Re: Control No. 07845, Application for Amendment of  
Materials License No. 22-00057-59MD

This letter is to provide clarifying information in support of our license amendment application of May 1, 1981, for I-125 Seeds in Carrier, model 6720. Included in this letter are responses to those items discussed in our telephone conversations of June 26 and 30, 1981, and July 1, 1981.

LEAD SHIPPING CONTAINER  
I-125 SEEDS<sup>R</sup>

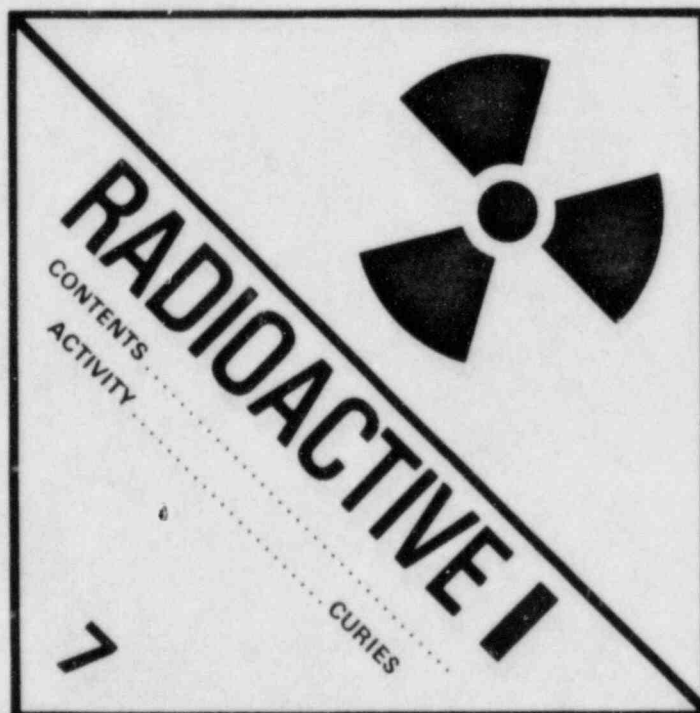
With regard to the source return policy described in the package insert, in what container does the customer return I-125 Seeds in Carrier? Please submit the instructions that you supply to customers who wish to return I-125 Seeds in Carrier.

The container which will be supplied to customers for return of I-125 Seeds in Carrier is a lead container, a schematic diagram for which is presented in Attachment A to this letter.
